Product/Process Change Notification

<Laser marking in Film & Paper production>

Date: 21-June-2019	ID Number (MMDDYY): PCN-190621-KB_Laser_mark																																													
Affected Products

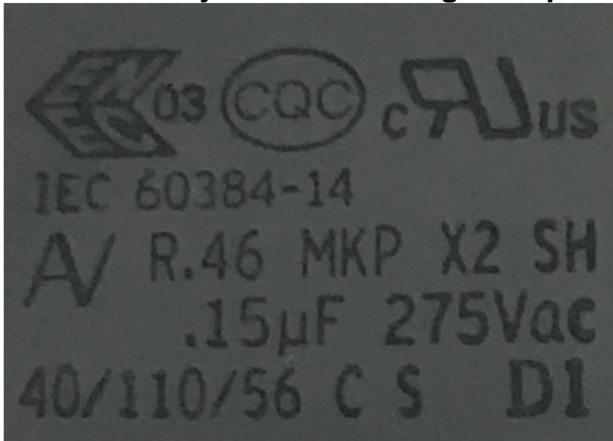
Justification and Benefits	<p>Increase of the production flexibility. </p> <p>Focus on the best practices in upgrading the marking tools and in using the latest state of the technology.</p>
Effective Date and Identification	<p>Starting date for order confirmation: August 1st 2019</p> <p>Intended date for initial deliveries September 1st 2019</p> <p>Without acknowledgement of this notification by July 31st, 2019 KEMET will proceed to implement the change as described herein.</p> <p>No specific identification will be stated on the label because no changes will be operated on the product with the exception of marking art.</p>
To Obtain Samples or General Information Contact	<p>Americas: Mrs. Laura LaBissoniere – Product Manager, LauraLabissoniere@kemet.com</p> <p>APAC: Mr Tony Yu – Product Manager, tonyyu@kemet.com</p> <p>Europe: Mrs. Katerina Bozhinovska – Product Manager, katerinabozhinovskai@kemet.com</p> <p>To obtain some example samples, please add the sentence “Laser Marking” in the request.</p>
